Revised Thruster Modification Cut Out Dimension

Figure 1. Thruster Modification

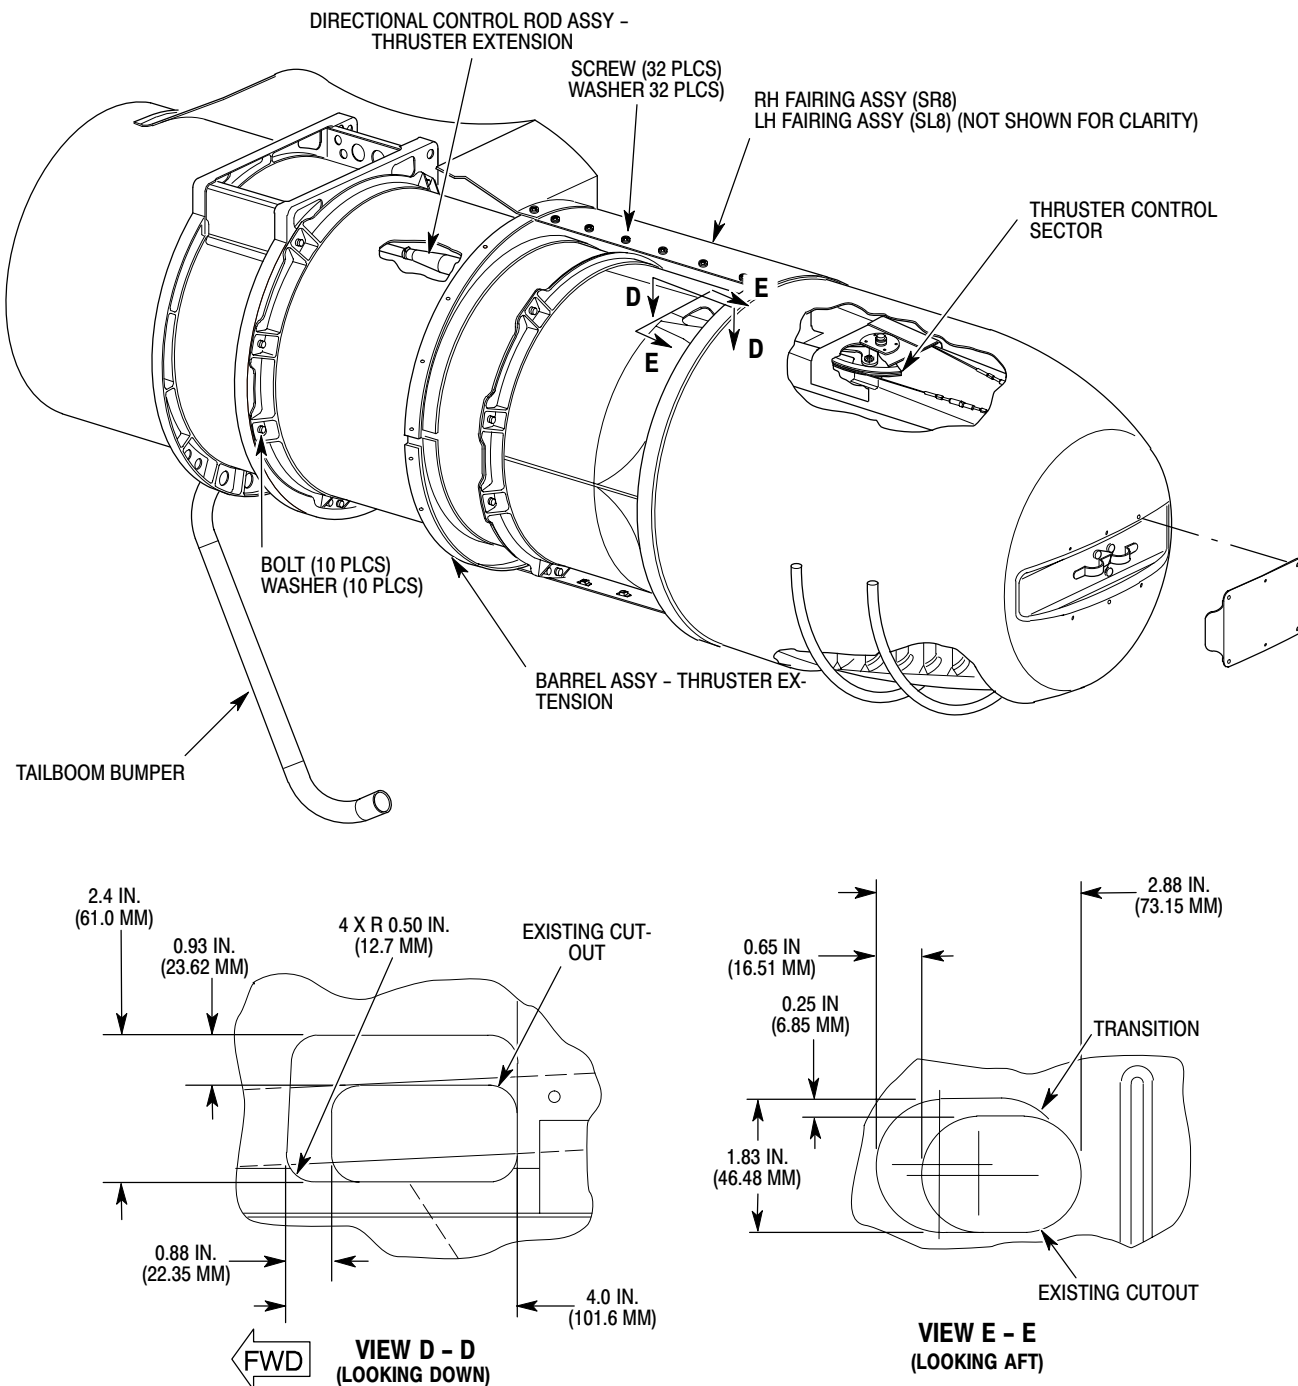
MD Helicopters, Inc. (MDHI) has found that on some aircraft the thruster cut out dimension published in SB900-099 is not sufficient to give clearance for the thruster control rod. To make sure there is correct clearance, use the cut out dimension that is shown in Figure 1.
